## Caiazza Comment on Draft Scoping Plan Scenarios

### Summary

There is a specific request for feedback on the components of the three mitigation scenarios as well as an implicit request for a recommendation for the appropriate scenario going forward. This comment presents my response.

*Figure 1: Screen capture of Figure 4 and its footnote on Section I - page 12. Note that there is no caption for the figure but there is a footnote. The footnote is the primary reference for the definition of the Reference Case*

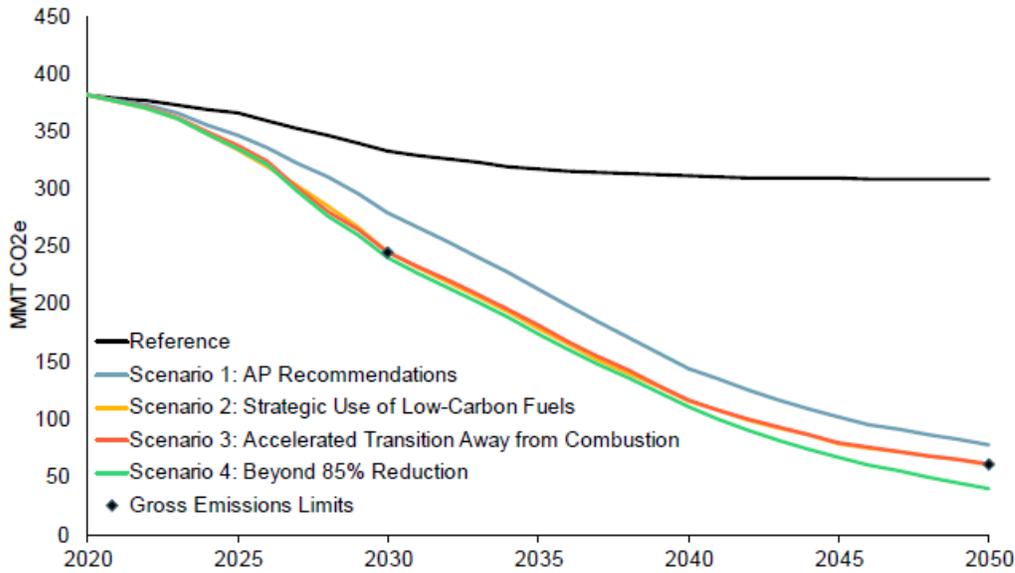
There is another aspect to Figure 1. In order to understand the true impact of these scenarios it is important to know what is included and what is not included. In particular the Reference Case “a business-as-usual forecast “inclusive of implemented policies”. The inclusion of implemented policies in the Reference Case means that many New York State policies that exist only to meet climate goals are not included in the expected costs of the three mitigation scenarios. This increases the cost of the Reference Case and decreases the relative difference between the mitigation scenarios and the Reference Case leading to the misleading claim that the costs of the Climate Act are several hundred billion dollars.

The footnote (6) for the preceding figure states that the Reference Case includes a business as usual forecast plus implemented policies, including but not limited to federal appliance standards, energy efficiency achieved by funded programs (Housing and Community Renewal, New York Power Authority, Department of Public Service, Long Island Power Authority, NYSERDA Clean Energy Fund), funded building electrification, national Corporate Average Fuel Economy standards, a statewide Zero-emission vehicle mandate, and a statewide Clean Energy Standard including technology carveouts.

The following table from [Annex 2: Key Drivers and Outputs Spreadsheet](#), Tab: Scenario Definitions lists specific programs in the Reference Case but details are lacking. In order to provide a full accounting of the control measures the Scoping Plan documentation should include a control measure description, the emissions reductions expected, and the costs expected for each of the scenarios. That information is

not provided so the Climate Action Council has not met the requirements of section 14,b of [§ 75-0103](#) in the Climate Act that states that the costs and benefits analysis must:

Figure 4: Draft Scoping Plan Page 72

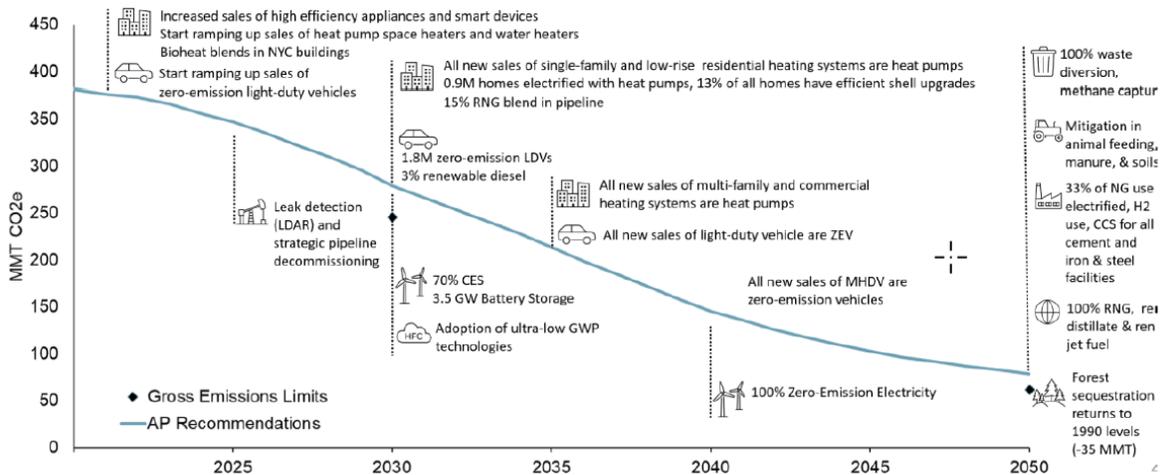
The following figure is a representation of the Advisory Panel recommendations. They provide a foundation for all scenarios; however, scenario modeling shows that further effort is needed to meet Climate Act emission limits.

Figure 1 Draft Scoping Plan Page 72

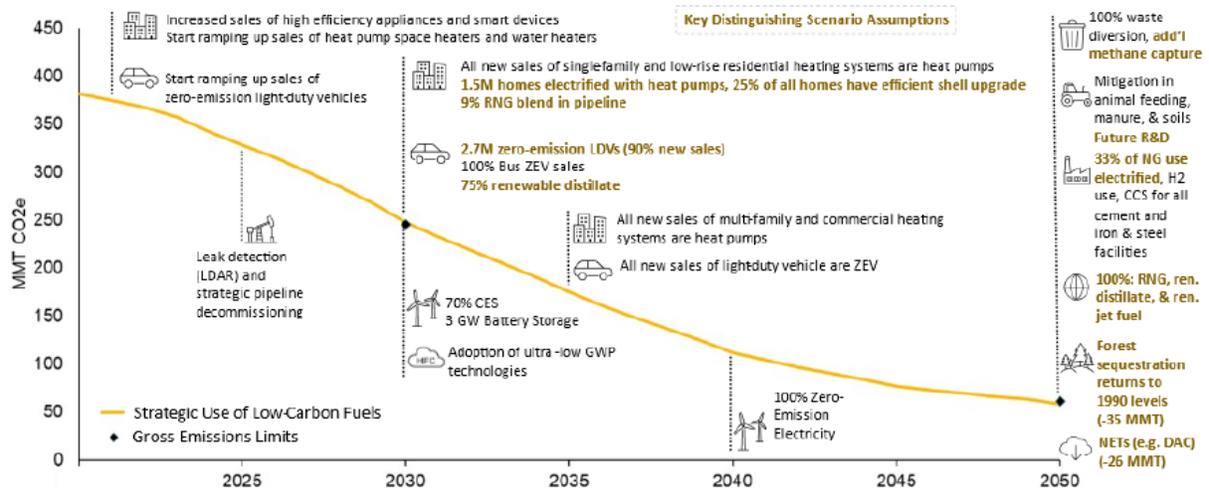
Advisory Panel recommendations were adjusted for strategic use of bioenergy derived from biogenic waste, agriculture and forest residues, and limited purpose grown biomass, as well as a critical role for green hydrogen for difficult-to-electrify applications. This scenario includes a role for negative emissions technologies to reach carbon neutrality.

Figure 2 Draft Scoping Plan Page 73

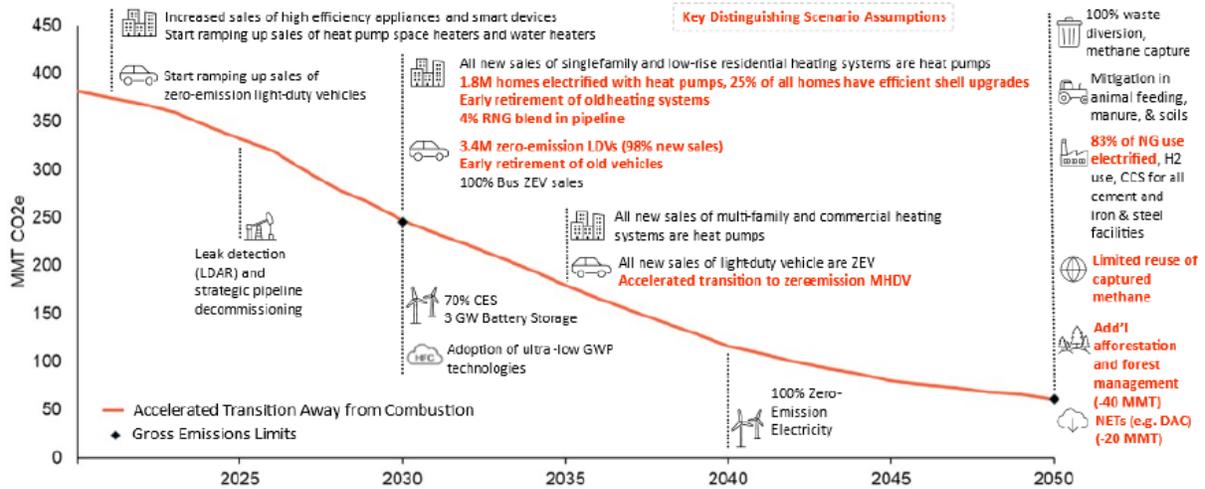
Advisory Panel recommendations adjusted to include a very limited role for bioenergy and hydrogen combustion and accelerated electrification of buildings and transportation. This scenario includes a role for negative emissions technologies to reach carbon neutrality.

*Figure 3 Draft Scoping Plan Page 73*

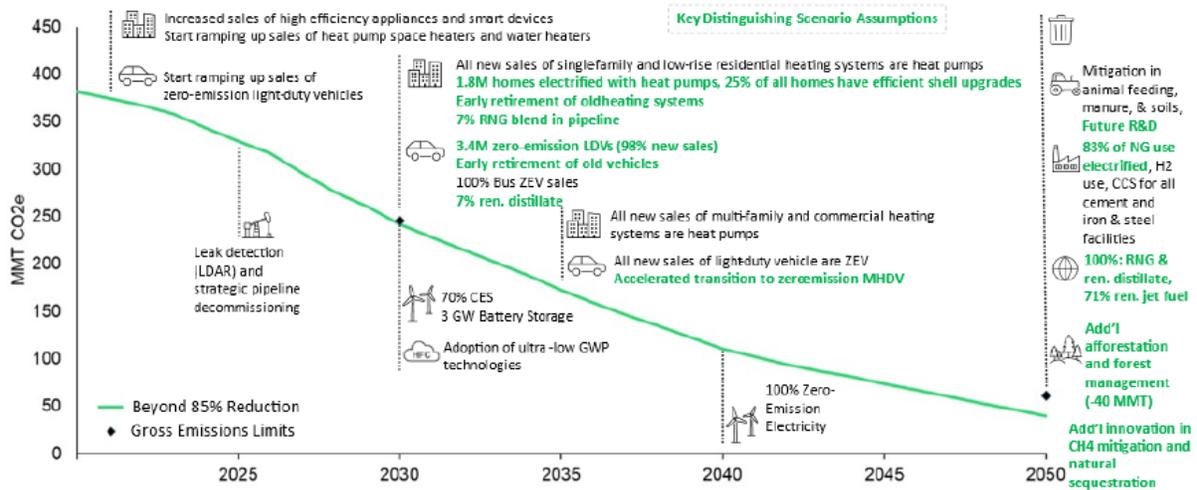
Advisory Panel recommendations adjusted to reflect accelerated electrification and targeted use of low-carbon fuels. This scenario includes additional reductions in VMT and innovation in methane abatement. This scenario reduces gross GHG emissions beyond the 2050 limit and avoids the need for negative emission technologies.
